Notice of Intent

Sundry ID: 2754851

Type of Action: APD Change

Procedure Description: Mewbourne Oil Company request a variance to perform break testing and offline cementing on the following wells: Querecho 23/26 Fed Com 523H Querecho 23/26 Fed Com 616H Night Watch 2/1 Fed Com 511H Night Watch 2/1 Fed Com 513H Gemini 36/35 Fed Com 513H Gemini 36/35 Fed Com 516H Corona 25/26 Fed Com 525H Corona 25/26 Fed Com 528H Pavo Macho 31/33 Fed Com 616H Pavo Macho 31/33 Fed Com 618H

Figure 3. BOP handling system

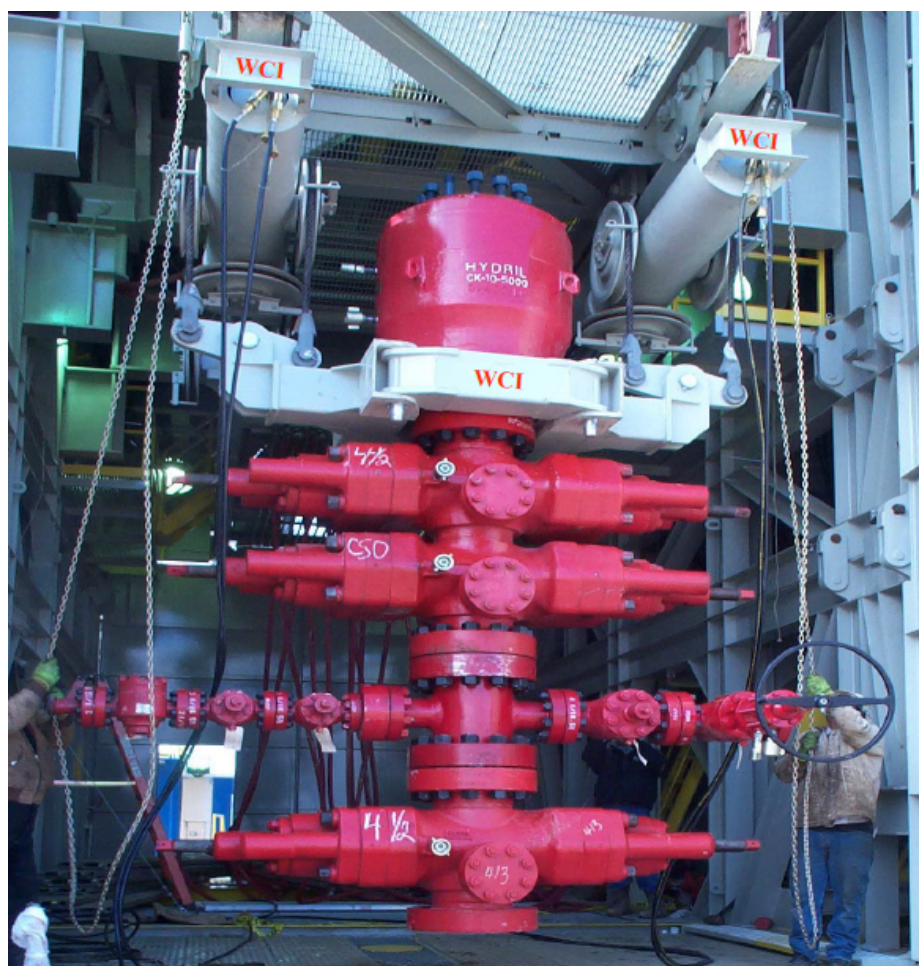
4. The BOP will be removed and carried by a hydraulic carrier (Fig. 3 & 4).
5. The rig will then walk to the next well.
6. Confirm that the well is static and remove the capping flange.

- While in transfer between wells, the BOPE shall be secured by the hydraulic carrier or cradle.
- Any well control event while drilling require notification to the BLM Petroleum Engineer **(575-706-2779)** prior to the commencement of any BOPE Break Testing operations.

Figure 5. Cactus 5M wellhead with BOP quick connect

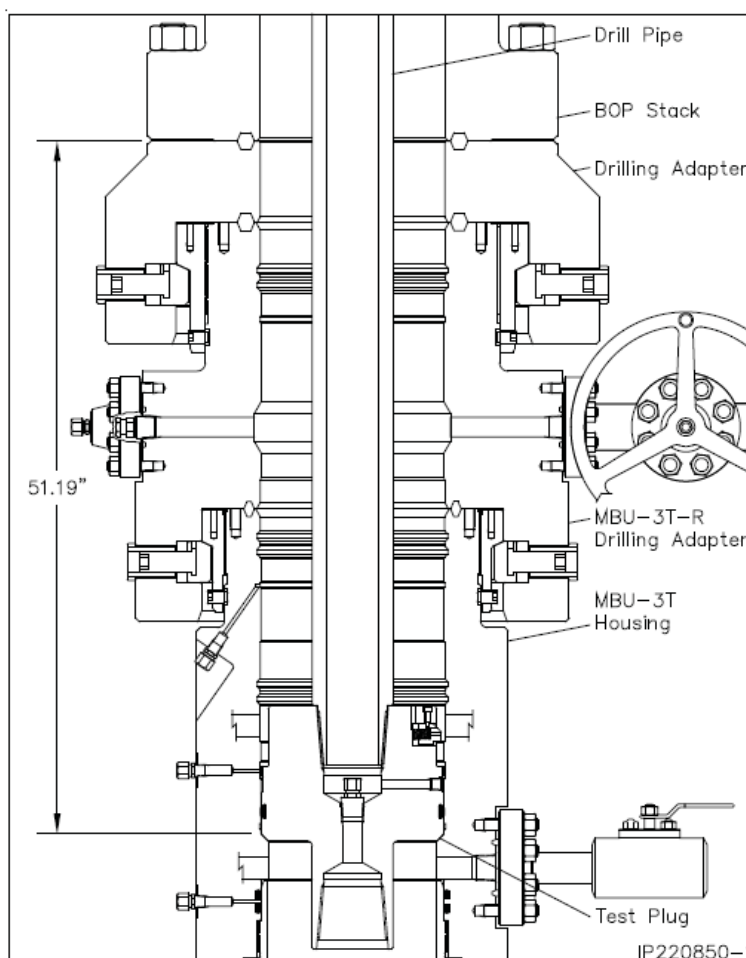
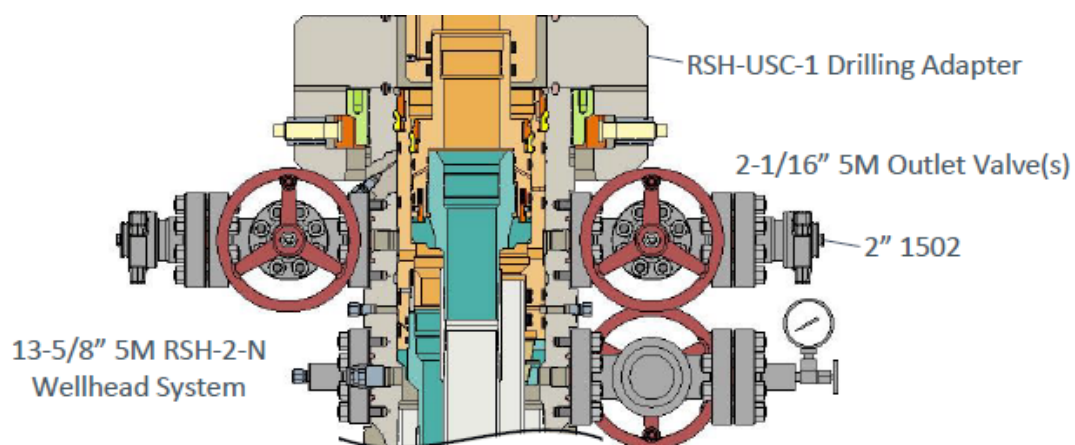
- Connection between the flex line and the HCR valve
 - Connection between the wellhead and the BOP quick connect (Fig. 5 & 6).
3. A capping flange will be installed after cementing per wellhead vendor procedure & casing pressure will be monitored via wellhead valve.
